Municipality of Anchorage

MEMORANDUM

SUBJECT: S12545, Canyon View Estates Subdivision, request for rehearing alleging new evidence or changed circumstances.

**S12545 CANYON VIEW ESTATES SUBDIVISION, LOT 1 – 27 AND TRACTS
A, B AND C.**

2016-013102

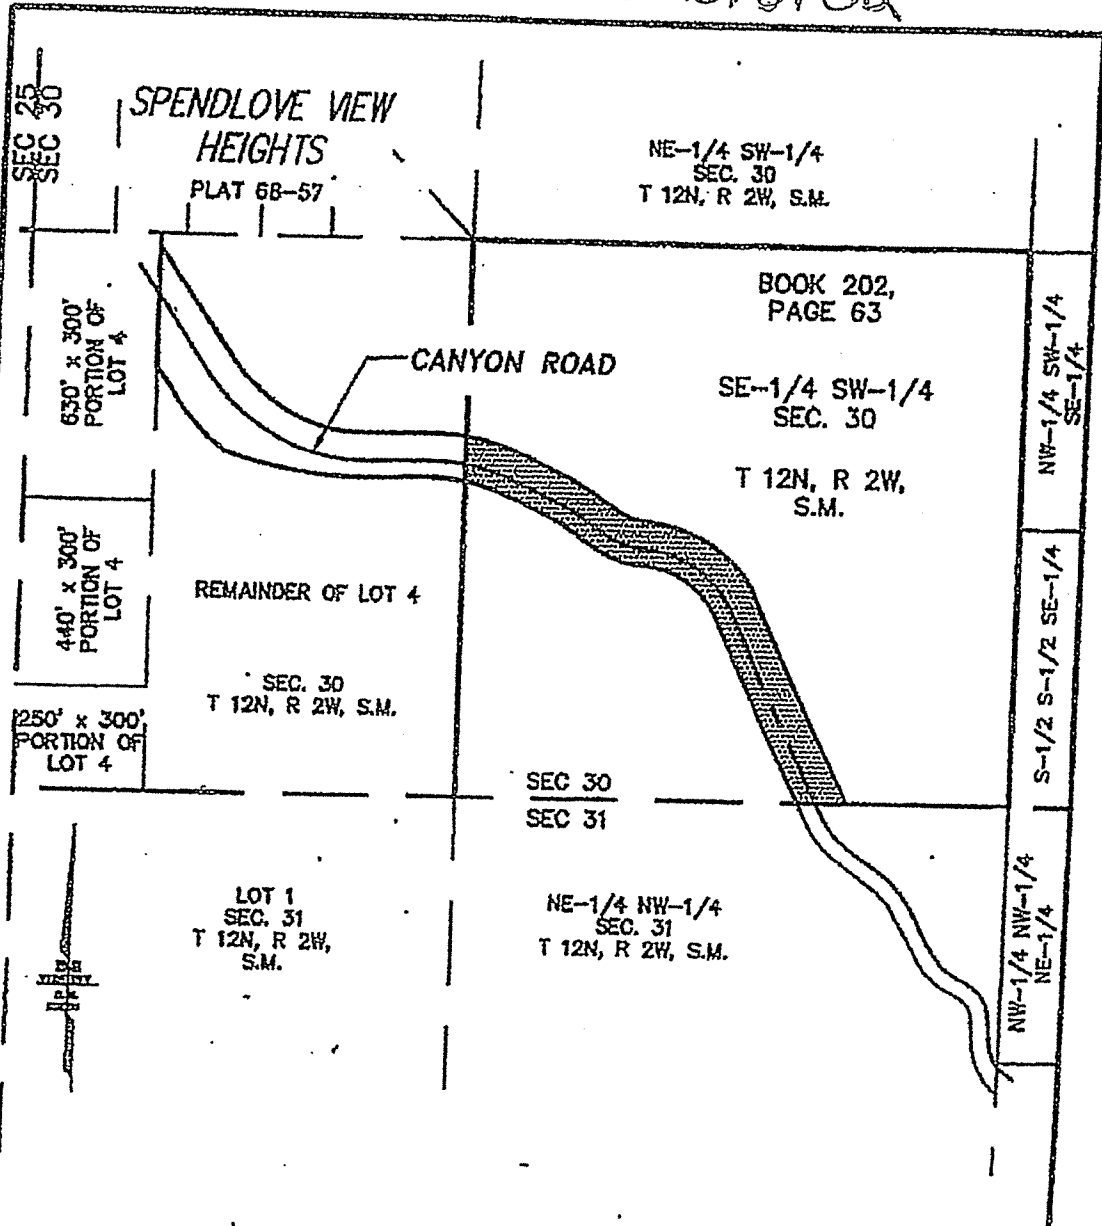
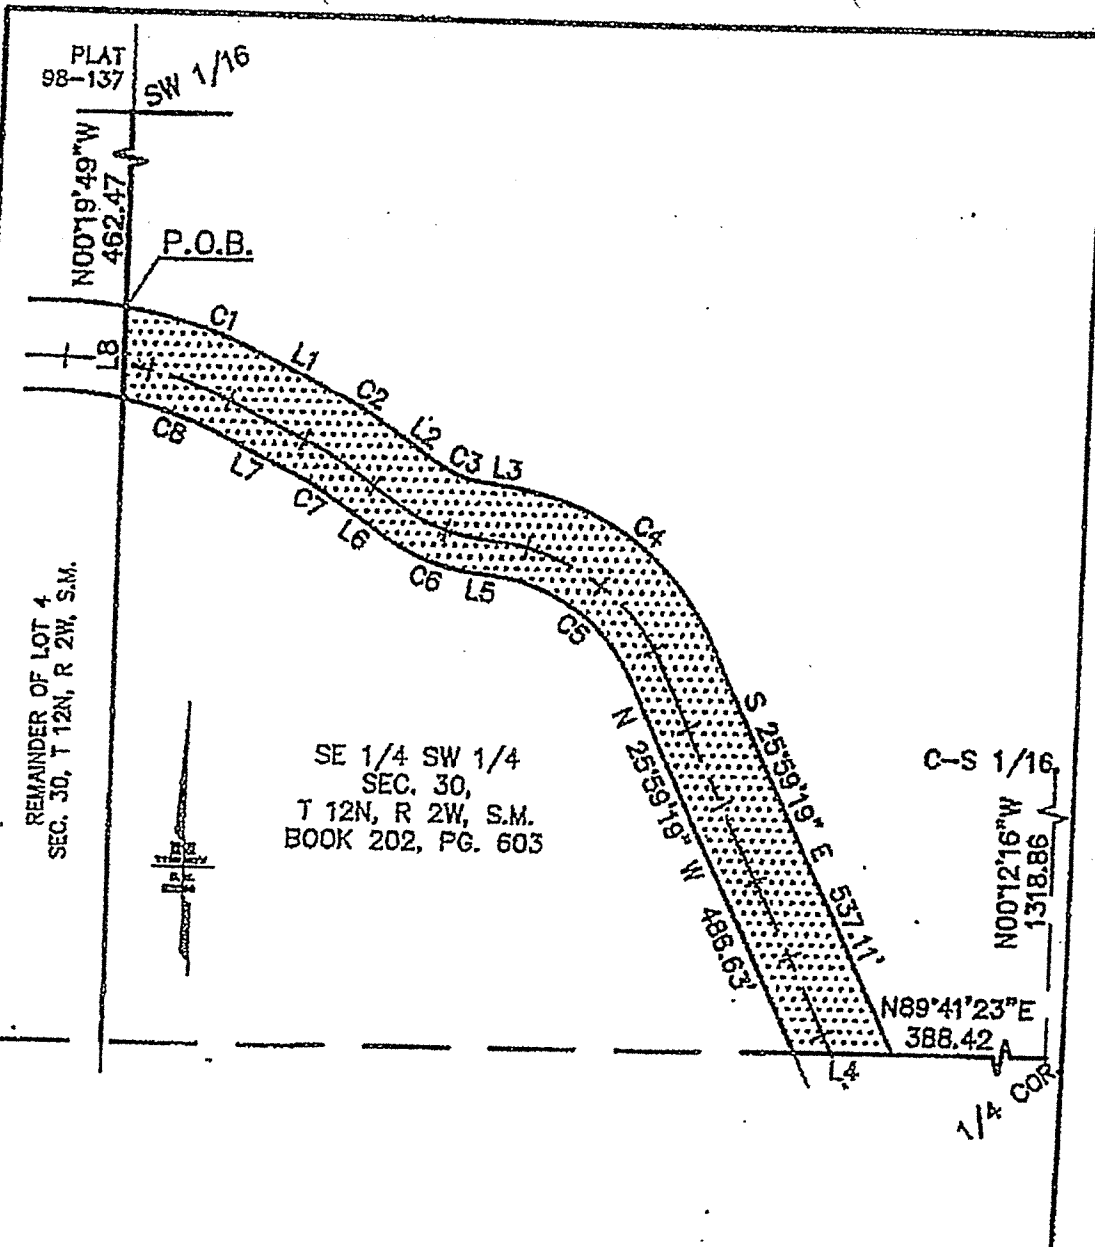
With this vacation request, it seems that the Hultquists assumed that all the rest of the land contained in the PUEs would basically be bestowed on them (at no cost), and these two PUEs would be terminated. Exhibit 9- diagram of Muni PUE 2016 013102, PDR p. 270-272, and Exhibit 10- diagram of Muni PUE 2016 013103, PDR p. 279-281, show the magnitude the land area that would be transferred to the applicants, as a present.

255
 Exh 20 112

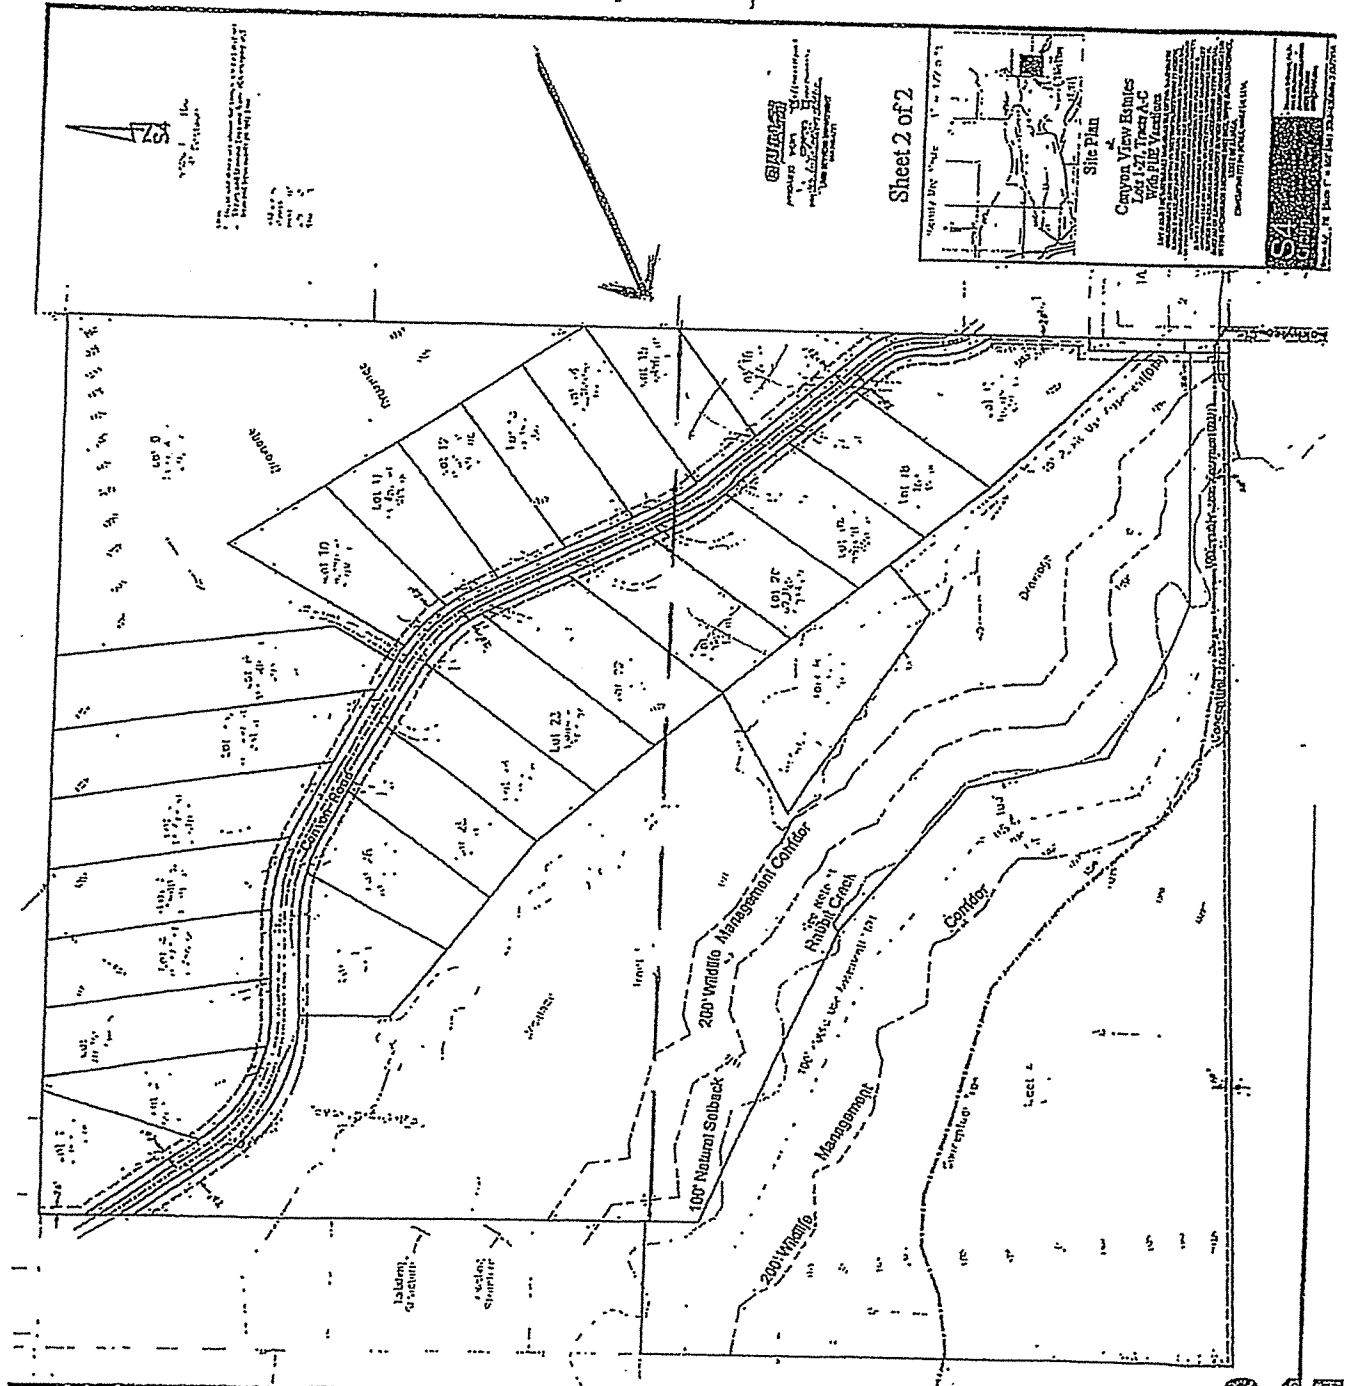
In the Certificate to Plat issued by the Alyeska Title Insurance Company in December of 2019, # 8 specifically lists "Reservation of section line easement 33 feet in width along each side of the section line. . ." (66 feet, total!) as an "exception to title" (Exhibit 28 - Alyeska Certificate, PDR p. 254-255). This phrase refers to East-West Section line 30-31, which stretches right across Lot 14, 15, 21 and 22 (Exhibit 29- Section line easement drawing, from PDR p. 345).

The whole Section line 30-31 (between the east and west geologic monuments) and its surrounding 66 foot wide easements have not been drawn on the proposed plat. Because this Section line indeed has a wide public access easement, and public importance, this situation will impact the plat plan and the allowable number and size of Lots. We think that this is an important omission, that could result in fewer Lots, still.
